RECORD OF DECISION

Proposed Infrastructure Improvements and Rentschler Field Development

East Hartford, Connecticut

JANUARY, 2007

**FIGURE 3
ROADWAY IMPROVEMENTS AT HIGH ST,
MAIN ST, BREWER ST, AND E.H. BLVD. S.**

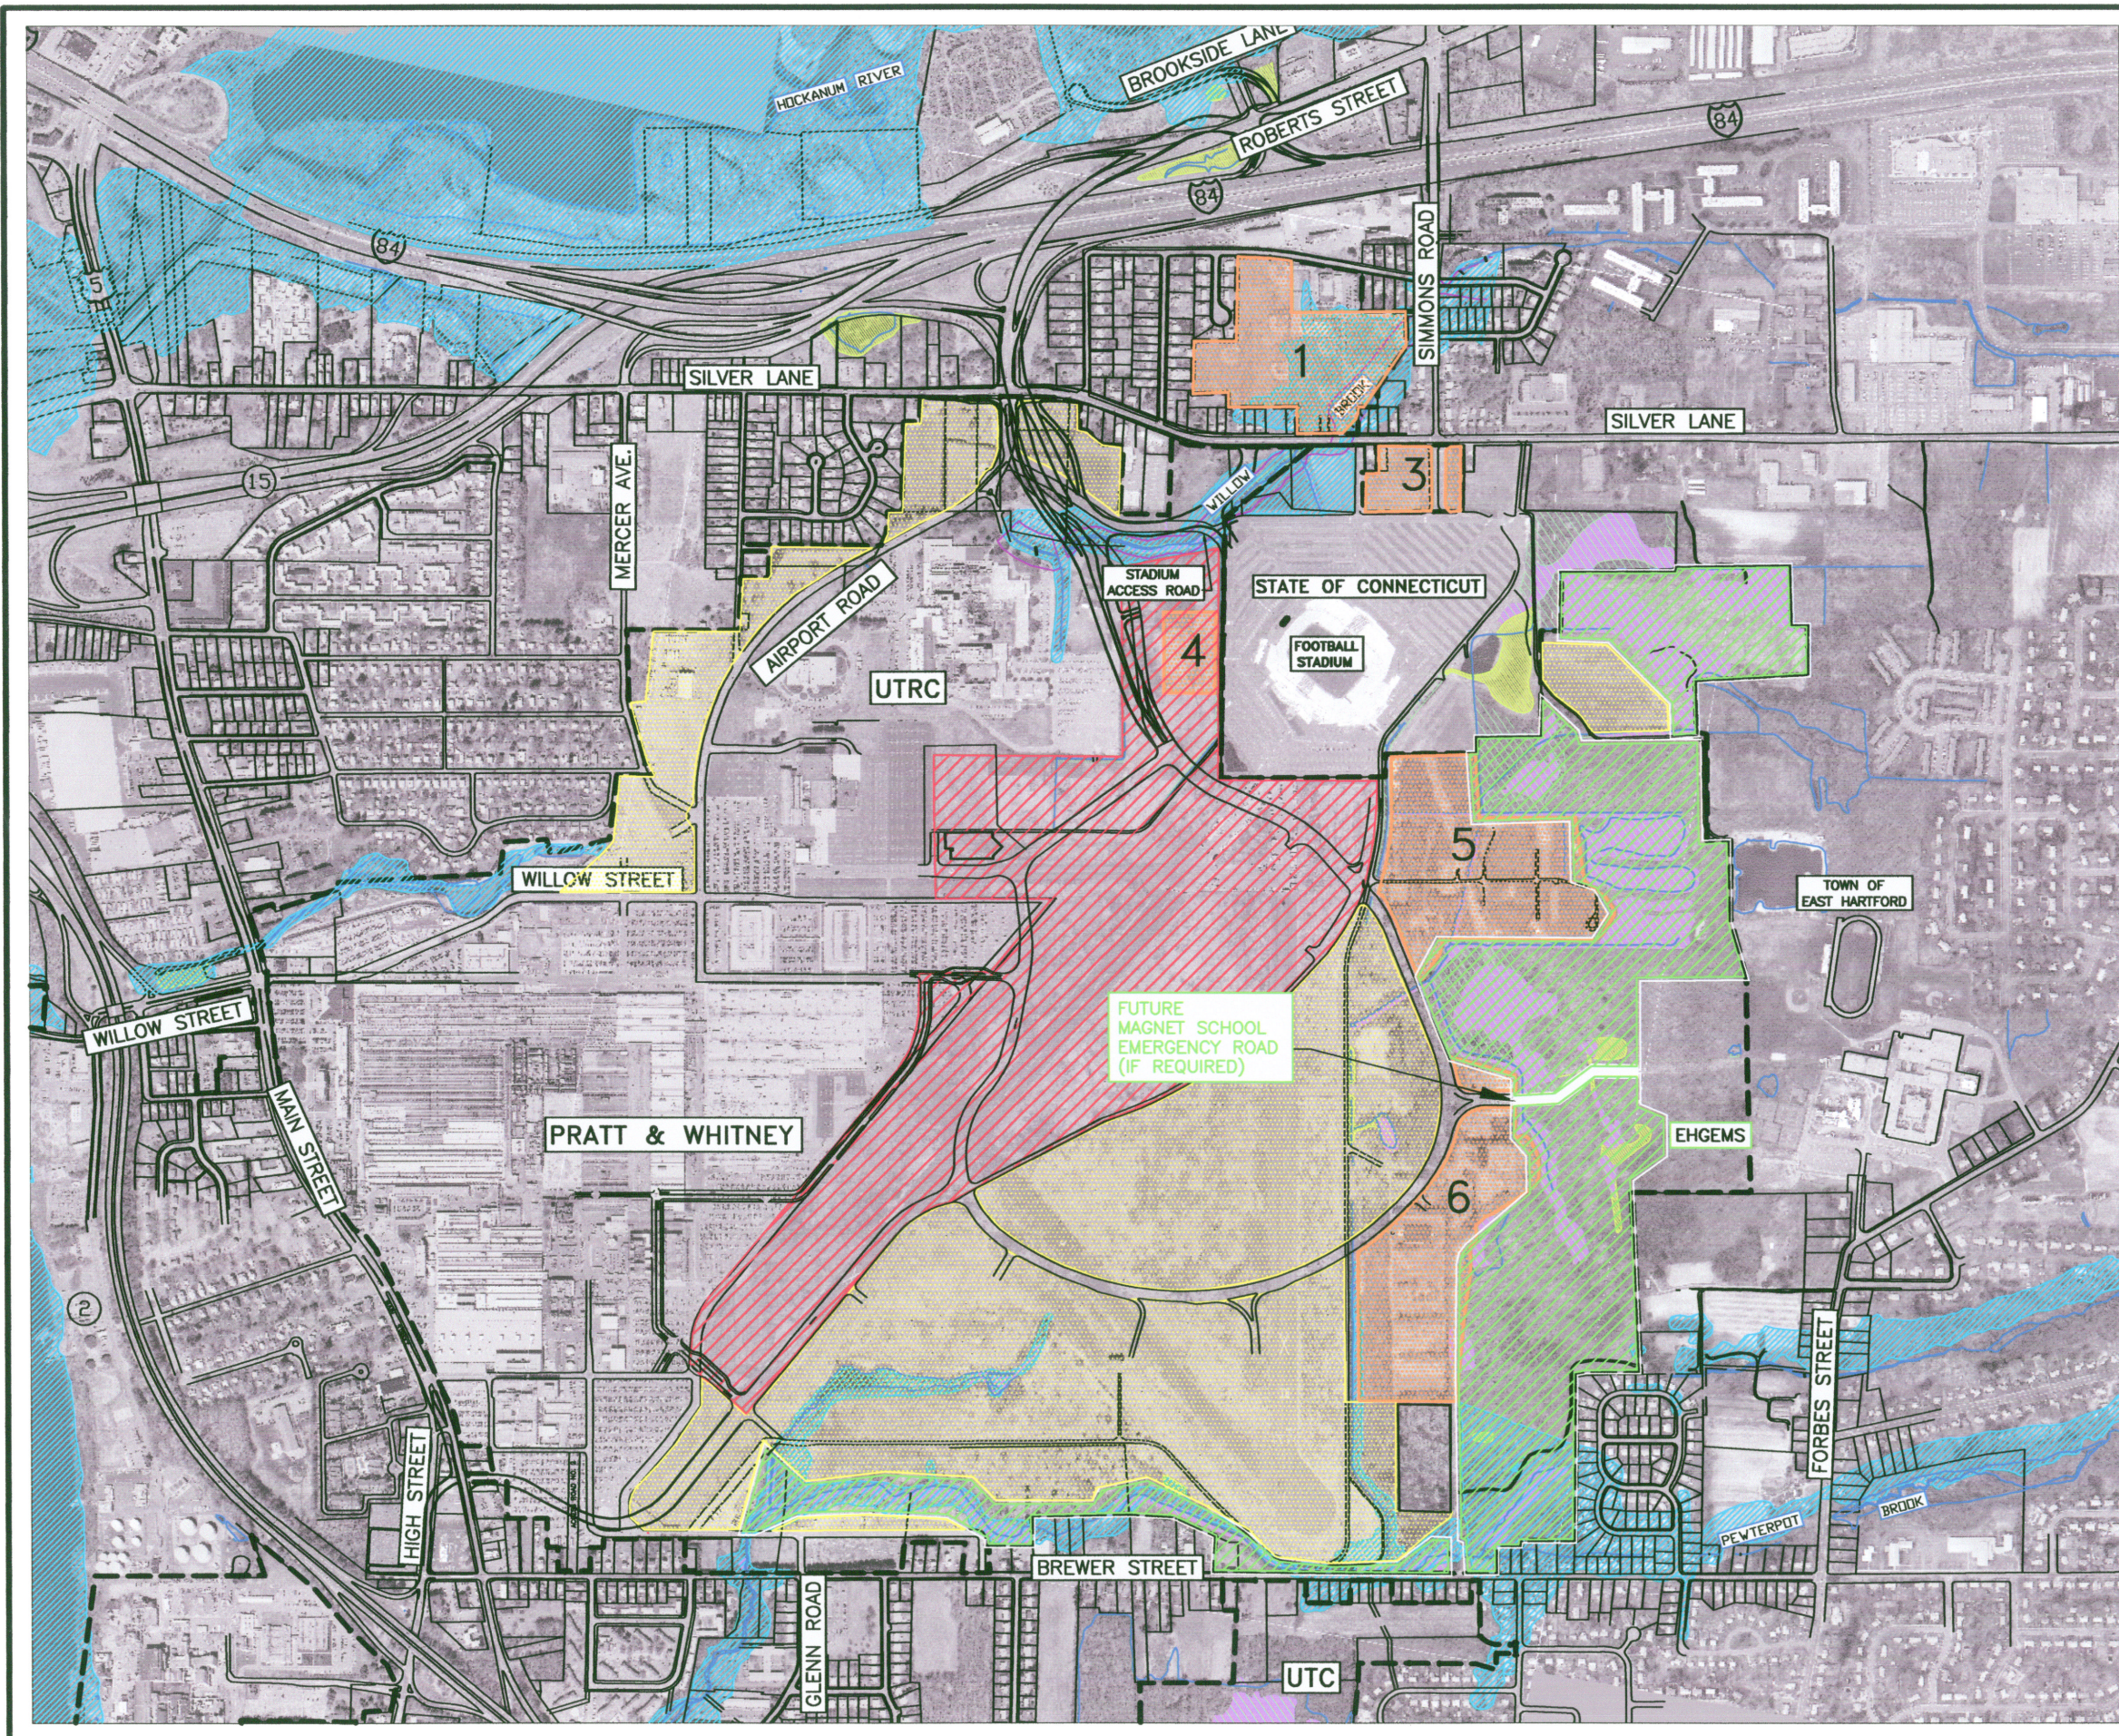
DOT-10 Comment: *"Figure ES-3 displays off-site improvements in the southern portion of the project area, which indicate a direct connection to the site from Main and High Streets. This appears to be an interim improvement, as previous discussions revealed that modifications to the Route 2 ramps in this area would be required for the full-build out. This office, therefore, has concerns about the viability*

DOT-9 Response: The southern offsite improvements shown in Figure 3 are the final recommended improvements. While more significant improvements were discussed during the preparation of the EIE. When the size of the proposed development was reduced to 5.7 million +/- square feet and traffic generation and distribution numbers were approved by DOT, the scope of the improvements was reduced. As shown in the analyses included in the EIE, all intersections studied in the vicinity of the Main Street/High Street/East Hartford Boulevard South intersections will operate at satisfactory levels of service once the proposed development is completed.

DOT-10 Response: See response to DOT-9.
